May 14, 2008

**Re: GE-Pittsfield/Housatonic River Site  
Groundwater Management Area 2 (GEC320)  
Long-Term Monitoring Program  
Addendum to Monitoring Event Evaluation Report for Fall 2007**

**FIGURE  
 A-1**

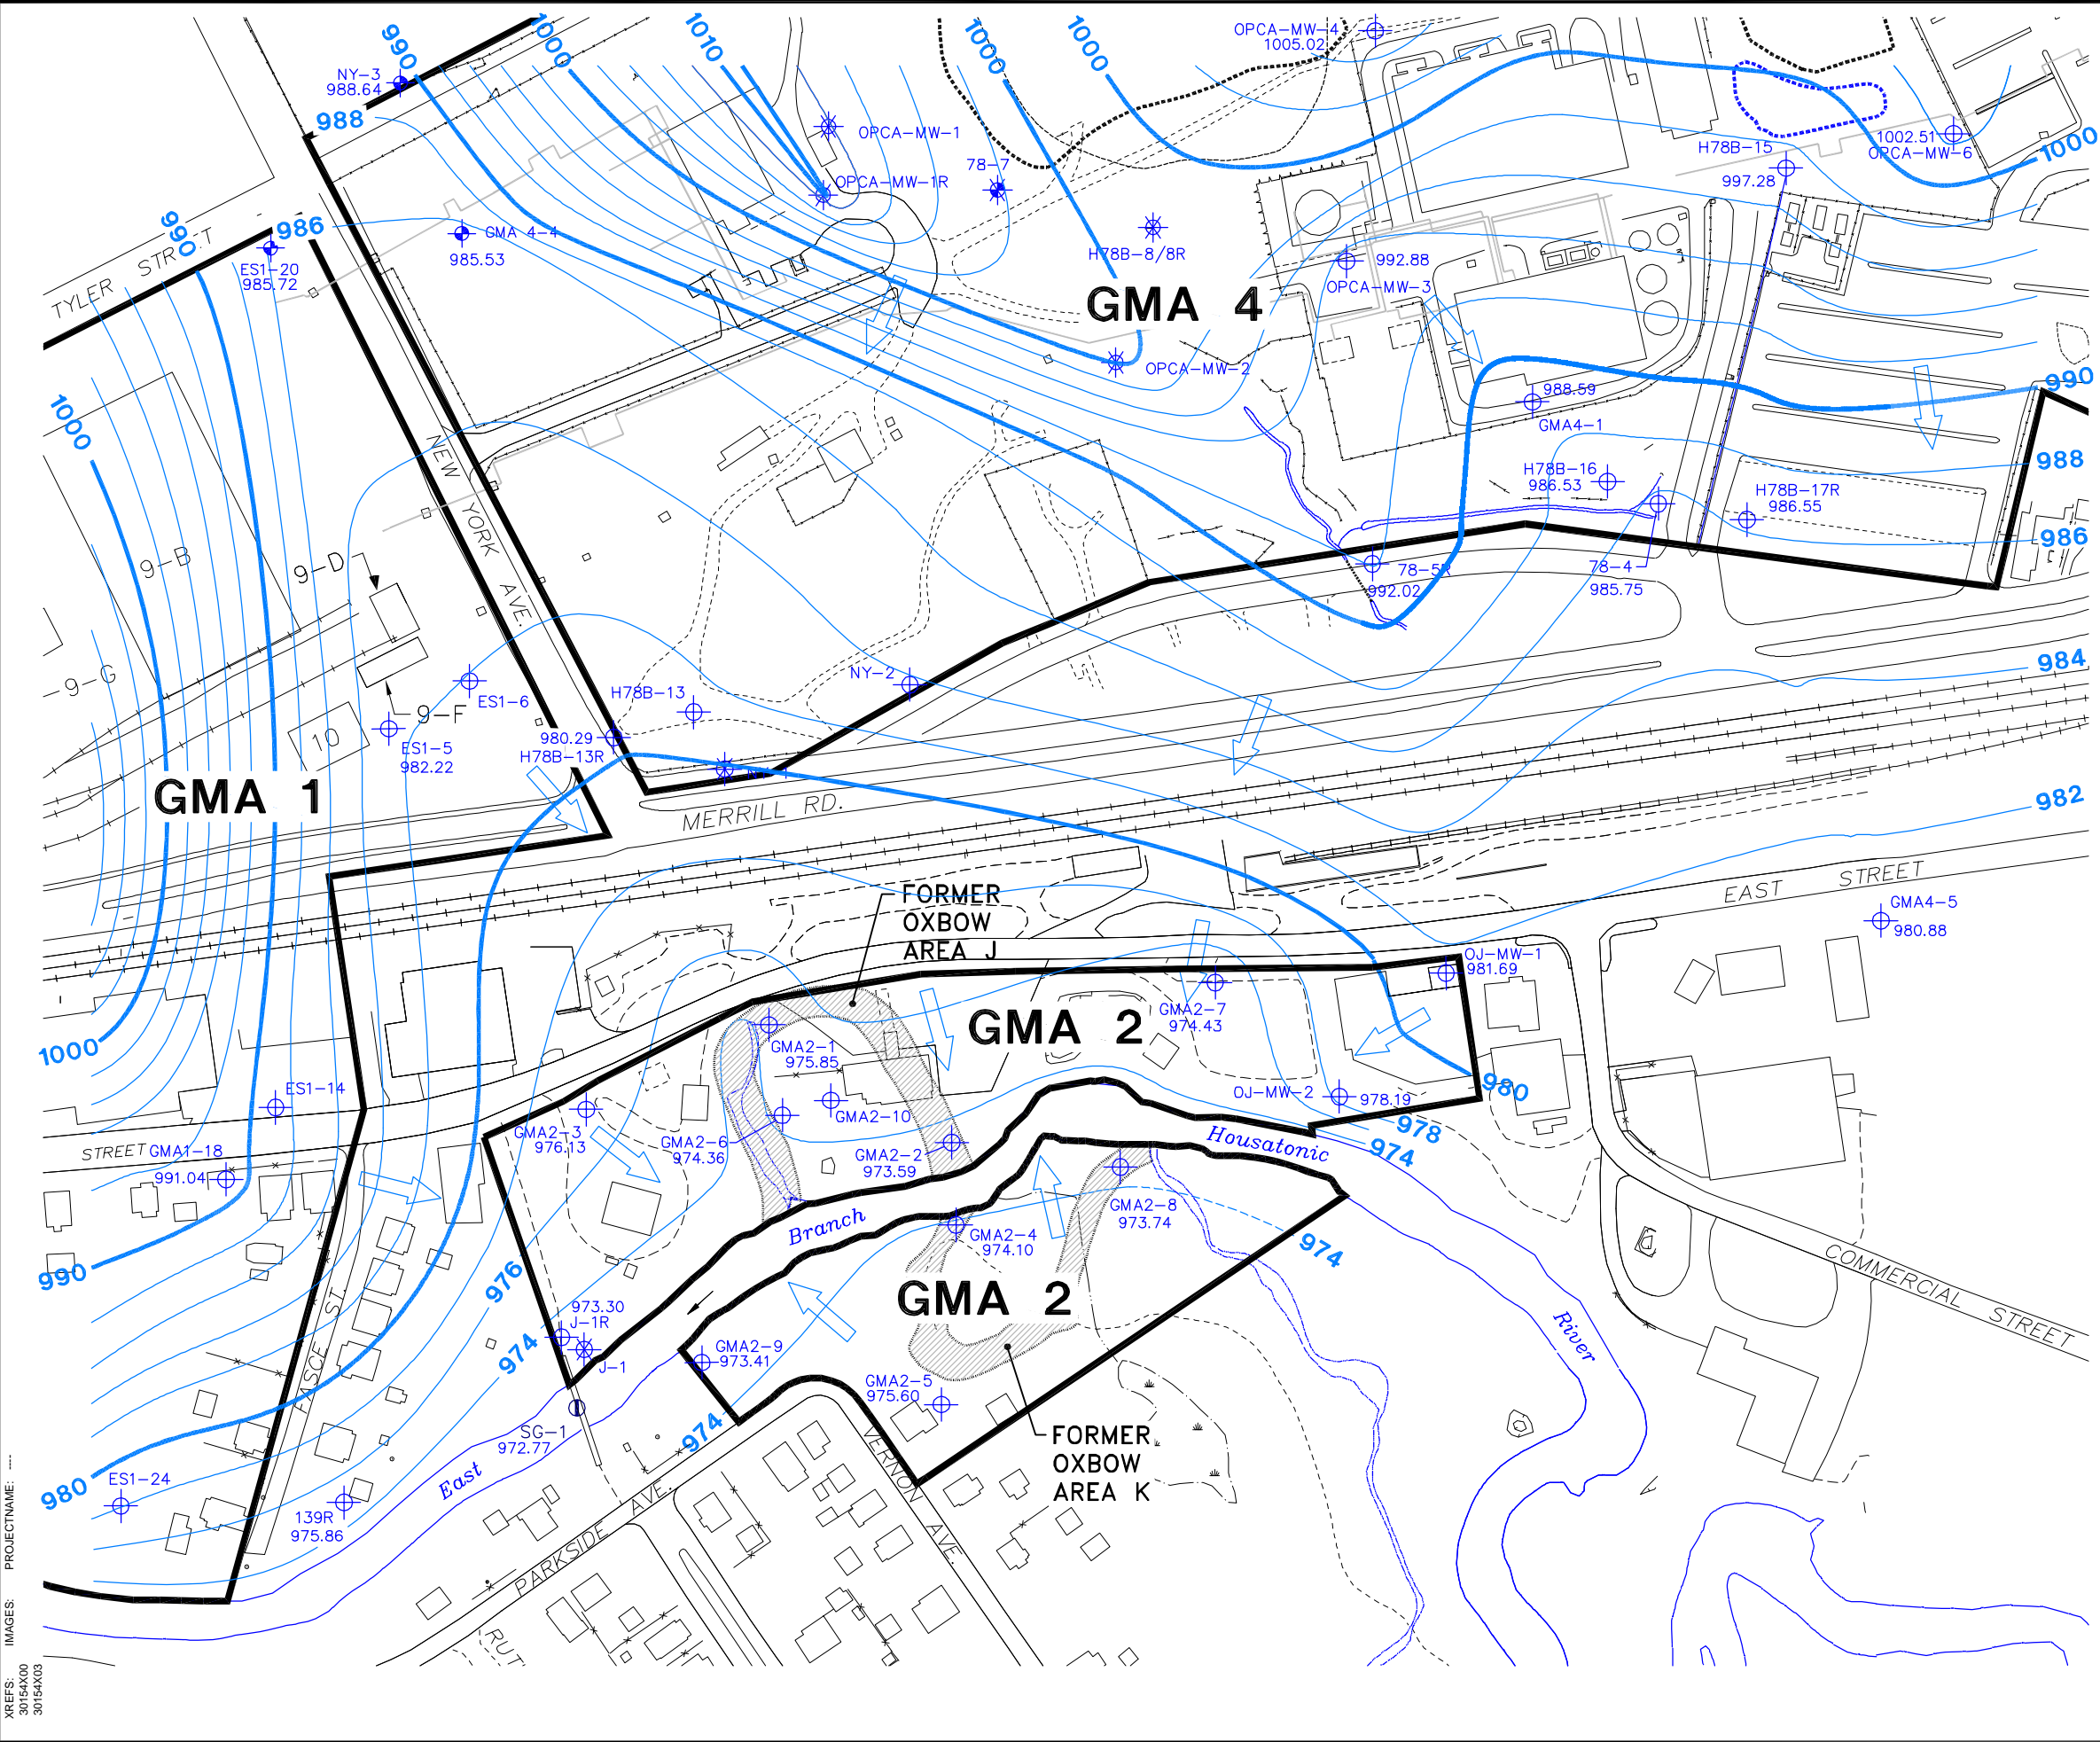
***In accordance with EPA's conditional approval letter dated October 9, 2007, GE shall submit an addendum to the Report including an assessment of the extent and concentration of PCBs and VOCs historically detected in wells at GMA 2 relative to monitoring results from the portions of GMA 1 and GMA 4 which are adjacent to and up gradient of GMA 2. The assessment shall include a determination of the relationship between the GMAs relative to groundwater flow and PCB and VOC concentrations and the need for any modifications to the LTMP. GE shall update and include this assessment with each Long-Term Monitoring Event Evaluation report.***

GE's assessment of PCB and VOC concentrations in GMA 2 groundwater relative to the adjacent upgradient portions of GMA 1 and GMA 4 is provided in Attachment A. As discussed in that attachment, the northern (Former Oxbow Area J) portion of GMA 2 is downgradient from parts of both GMA 1 and GMA 4. Certain VOCs and PCBs detected in GMA 2 groundwater have also been observed in monitoring wells along the downgradient edges of the adjacent portions of GMA 1 and GMA 4. However, several other VOCs have only been observed in one of the upgradient GMAs, but not in GMA 2, or they have been observed in GMA 2, but not in the adjacent GMA. All of the commonly detected

As shown on Figure A-1, groundwater flow patterns at GMA 2 and surrounding areas generally reflect the topography of the site with an overall flow towards the Housatonic River. The northern (Former Oxbow Area J) portion of GMA 2 is downgradient from parts of both GMA 1 and GMA 4. Specifically, groundwater from the eastern portion of GMA 1 appears to flow toward the Housatonic River across the western portion of GMA 2, while groundwater from the western and central portions of GMA 4 appears to flow across the central and eastern sections of GMA 2. A groundwater divide extending northwest to southeast that has been identified across GMA 4 may serve to limit groundwater migration from the eastern portion of GMA 4 toward GMA 2.
